Access Compliance Report

Public Rights-of-Way

(Curb Ramps)

Intersection ID: 10041482	Main Street: WESTPARK_DR	Cross Street: N/A	Location: NE
ADA ID: 369A7E4B150C	Ramp Type: Directional1	Initial Pass/Fail: Fail	Overall Compliance: No
Codes/Mitigation Info/Possible Solution		Field Measurements/Component Compliance	
Severity Score: 10

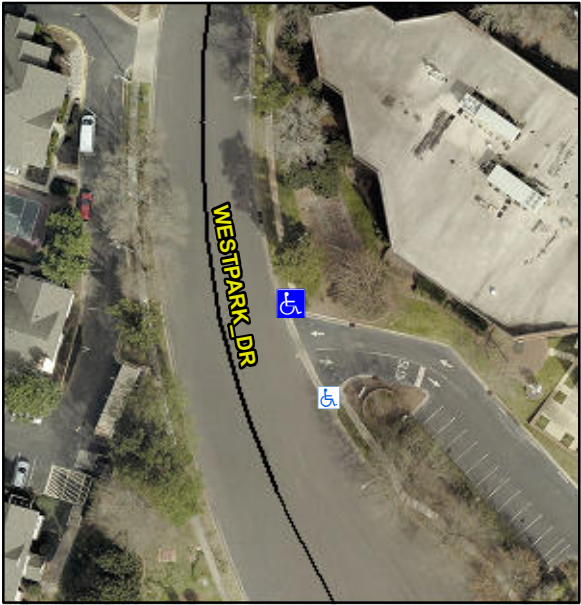
Possible Solutions:	Compliance	Description	Data	Compliance	Description	Data
	Remove & Replace Entire Ramp.	N/A	Ramp Length (in)	51.0	N/A	Grade Break?	N/A
		No	Ramp Width (in)	47.0	N/A	Grade Break Slope (%)	0.0
		Yes	Ramp Slope (%)	0.6	N/A	Grade Break XSlope (%)	0.0
		No	Ramp XSlope (%)	4.5			
		N/A	Flare Type LT	N/A	N/A	Flare Type RT	N/A
		N/A	Flare Slope LT (%)	N/A	N/A	Flare Slope RT (%)	0.0
		N/A	Flare Traversable LT?	N/A	N/A	Flare Traversable RT?	N/A
	Surveyor Notes:	N/A	Landing Length (in)	0.0	N/A	DWS Provided?	N/A
		N/A	Landing Width (in)	0.0	N/A	DWS Contrast?	N/A
		N/A	Landing Slope (%)	0.0	N/A	DWS Length (in)	N/A
		N/A	Landing X Slope (%)	0.0	N/A	DWS Full Width?	N/A
	PROW/ADA:	N/A	Landing Curb? (Y/N)	N/A	N/A	DWS Offset LT (in)	N/A
	R304.5.1, R304.5.3	N/A	Shared Landing?	N/A	N/A	DWS Offset RT (in)	N/A
		N/A	Gutter Ponding?	0.0	N/A	Gutter Slope (%)	N/A
		N/A	Gutter Lip Ht (in)	0.0	N/A	Gutter X Slope (%)	N/A

N/A	Painted X Walk1?	No		Road Slope (%)	0.4
			X Walk 1 Direction	To S		Road X Slope (%)	9.8
			X Walk 1 Width (in)	N/A		Clear Space?	N/A
			X Walk 1 Slope (%)	0.4	N/A	Clear Space to XWalk (in)	N/A
			X Walk 1 X Slope (%)	9.8	N/A	Storm Grate/Utility Hazard?	N/A
		N/A	Ramp inside XWalk1?	N/A		Storm Grate/Utility Type	
		N/A	Any Obstructions?	N/A			N/A
			Obstruction Type		Yes	Surface Condition? (G/P)	Good
					N/A	Curb Slope (%)	11.8
Street 1 Name	ENTRANCE						
Stop Condition-Street 1	StopSign						
Street 2 Name	N/A						
Stop Condition-Street 2	N/A						
Total Cost:		\$	1600.00
